**Sylvia Jeffrey Site
Queensway Industrial Estate
Wrexham**

Highway Statement

From:	Chief Officer, Environment & Technical	To:	Chief Officer Economy & Planning
		FAO::	Gwyn Humphreys
Our Ref:	ET/DC/PP/P/2023/0745	Your Ref:	P/2023/0745
Date:	22/11/2023

**TOWN AND COUNTRY PLANNING ACT 1990
NEWID DEFNYDD ADEILAD O DDOSBARTH B2 (WARWS DIWYDIANNOL) I DDOSBARTH A1
(WARWS MANWERTHU) A DOSBARTH B8 (STORFA A DOSBARTHU) / CHANGE OF USE OF
BUILDING FROM CLASS B2 (INDUSTRIAL WAREHOUSE) TO CLASS A1 (RETAIL
WAREHOUSE) AND CLASS B8 (STORAGE AND DISTRIBUTION)**

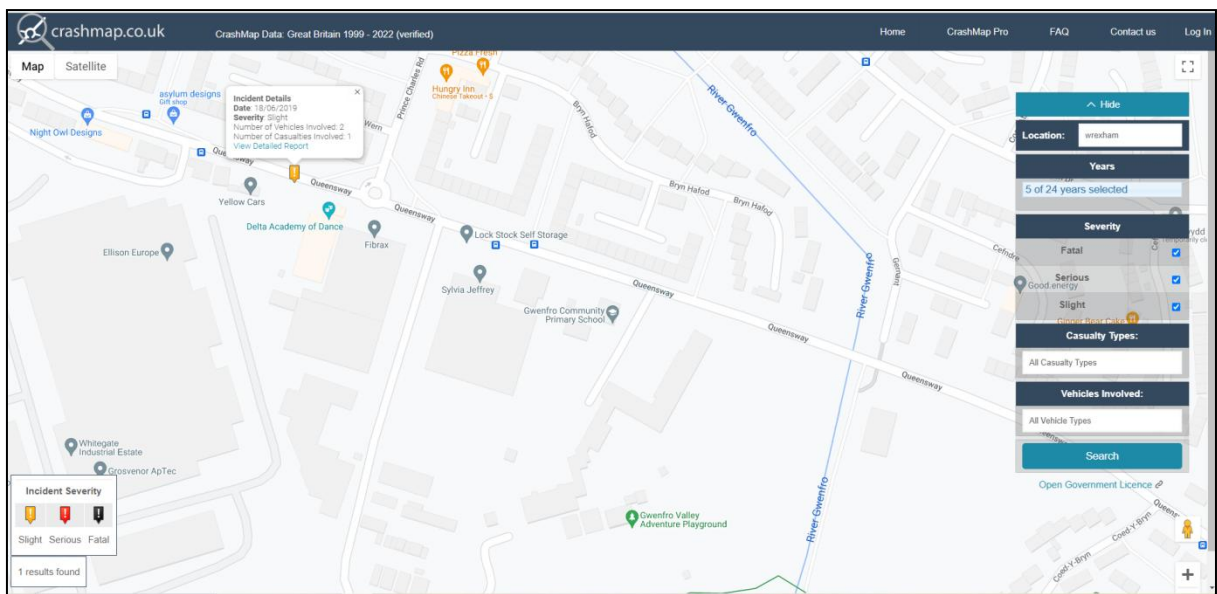
6.2 The following extract from the CrashMap database highlights the locations of both the Sylvia Jeffrey and Fibrax gateways; the lack of recorded accidents is an indication that the accesses have operated without incident over the full period of 24 years of available data.

(the recorded incident, positioned within the factory yard, has been incorrectly plotted on the database and actually relates to an incident on a pedestrian crossing on the A525)
